Access Compliance Report Public Rights-of-Way (Curb Ramps)

Main Street: N/A		Cross Street: ANTONIO_PKWY		Location: S	
ADA ID: RPRK211202124328	Ramp Type: Type 7 - Directional 2	Initial Pass/Fail: Fail	Overall Compliance: No	Severity Score: 15	
Codes/Mitigation Info/Possible Solution			Field Measurements/Component Compliance

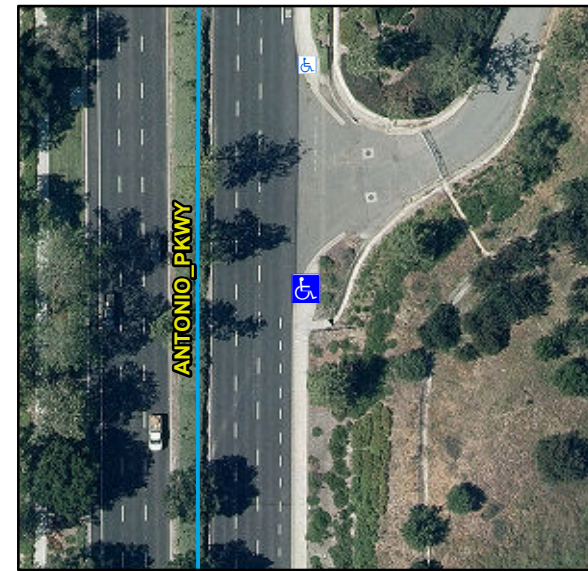
Compliance	Description	Data	Compliance	Description	Data
N/A	Ramp Length (in)	176	N/A	Flare Type LT	
Yes	Ramp Width (in)	70			N/A
No	Ramp Run Slope (%)	10.3	N/A	Flare Slope LT (%)	N/A
Yes	Ramp Cross Slope (%)	0.2	N/A	Flare Traversable LT	N/A
N/A	Grade Break	N/A	N/A	Flare Type RT	
N/A	Grade Break Slope (%)	N/A			N/A
N/A	Grade Break Cross Slope (%)	N/A	N/A	Flare Slope RT (%)	N/A
	Addl Para Ramp Left?	No	N/A	Flare Traversable RT	N/A
	Addl Para Ramp Right?	No	N/A	DWS Provided	N/A
N/A	Landing Present	N/A	N/A	DWS Contrast	N/A
N/A	Landing Length (in)	N/A	N/A	DWS Length (in)	N/A
N/A	Landing Width (in)	N/A	N/A	DWS Full Width	N/A
N/A	Landing Run Slope (%)	N/A		DWS Offset Type	N/A
N/A	Landing Cross Slope (%)	N/A	N/A	DWS Left Offset (in)	N/A
N/A	Landing Movement Obstructed?	N/A	N/A	DWS Right Offset (in)	N/A
	Landing Movement Type	N/A			
N/A	Landing Shared	N/A			
N/A	Marked Crosswalk 1	No	N/A	Clear Space	N/A
	Crossing 1 Direction	N	N/A	Clear Space To Crosswalk (in)	N/A

Remove & Replace Entire Ramp.
